Re: Rapiscan AIT System Radiation Survey Reporting

Rapiscan systems	Secure 1000 Radiation Emission Measurement	FORM R-0646-1 (Single Pose)
----------------------------	---	--------------------------------

**R-0646-1 Addendum
(Documentation Errors)**

Product Name	Secure 1000SP (Single Pose)
Serial Number	S51012008
Radiation Emission Measurement	Radiation Survey Dated: 11/11/2010
RSO Initials

1. In Beam Dose Measurement: Survey Table. 1

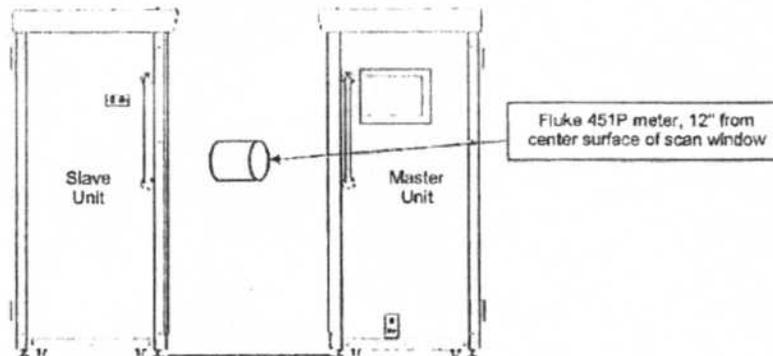
TABLE 1: Incorrect presentation of data in Column 3 for Measured Exposure. Indicated value is 0.121 uRem. Corrected value is 1.21 uRem. The value was corrected by technician when calculating Effective Dose.

RSO will address issue with technician to ensure error is not repeated.

The corrected data indicates this system was operating within expected parameters. No re-survey is required for this system.
